REPAIR

ON-SITE SEWAGE DISPOSAL SYSTEM HOWARD COUNTY HEALTH DEPARTMENT BUREAU OF ENVIRONMENTAL HEALTH

ADDRESS: 13850 Wayside Drive

PROPERTY OWNER: Richard Armacost

NEW SYSTEM ILLUSTRATED BELOW

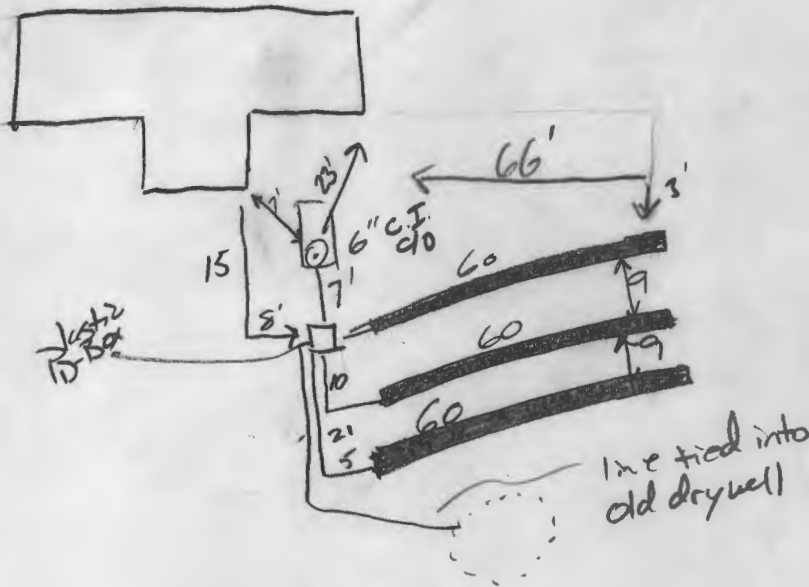
PRE-CONSTRUCTION 5-2-03 MEASURED TO neighboring wells. ONLY WELL DOWNSLOPE IS ACROSS the street and not directly INSTALLATION downslope; distance >200' away. Dry well stone filled with effluent at 4 1/2' - failing. Pump Dry well & fill with stone for emergency overflow or future repair. Use a leveler in dist. box to set drywell inlet higher than the three - 60' trenches (KN)

INSTALLATION 5/15/03 material uphill of pre test got better at a shallower depth. Pipe is being installed @ 4' with a bottom of .7'. Inspected 1st + 2nd trench. O.K. to back fill 1st + 2nd trench. 5/16/03 O.K. to backfill 1st trench.
